SUNDRY NOTICES AND REPORTS ON WELLS

Devon Energy Production Company, L.P. gives notification of bottom hole change. Attached is a copy of the new C-102, Survey, Plot, and Drilling Plan.

WELL LOCATION AND ACREAGE DEDICATION PLAT

¹ API Number 30-045-34319	² Pool Code 96175	³ Pool Name Rosa Pictured Cliffs
⁴ Property Code 19641	⁵ Property Name NEBU	⁶ Well Number # 247
⁷ OGRID No. 6137	⁸ Operator Name Devon Energy Production Company, L.P.	⁹ Elevation 6335

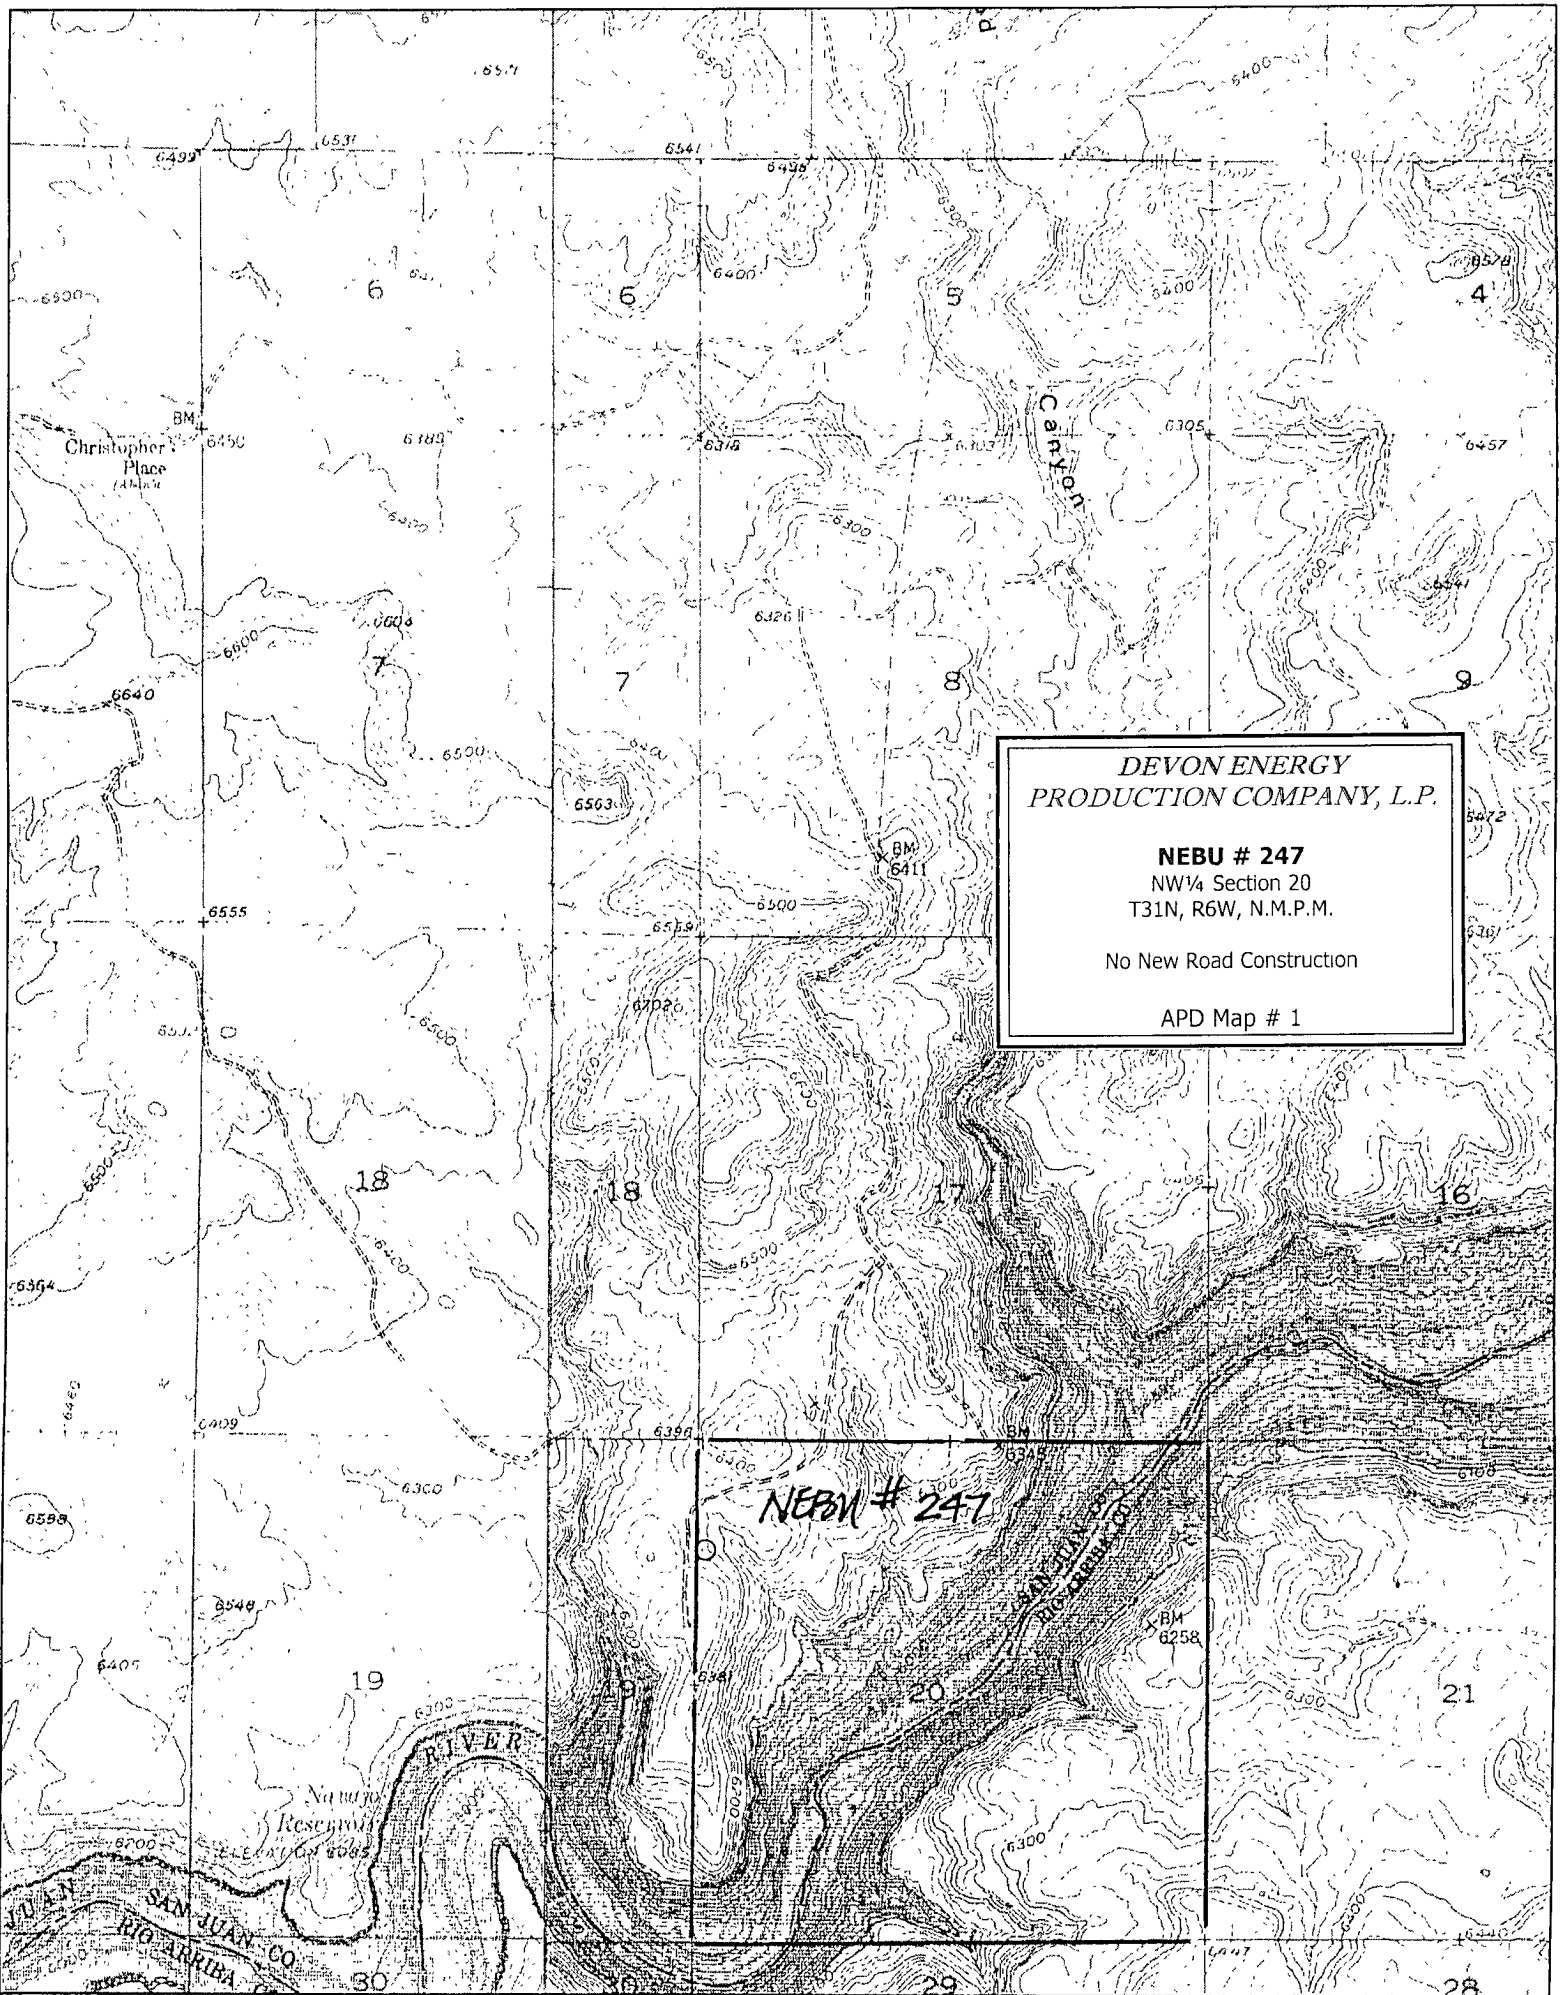
¹¹ Bottom Hole Location If Different From Surface

UL or lot no.	Section	Township	Range	Lot Idn	Feet from the	North/South line	Feet from the	East/West line	County
L	20	31 N	6 W		1950	SOUTH	1140	WEST	SAN JUAN
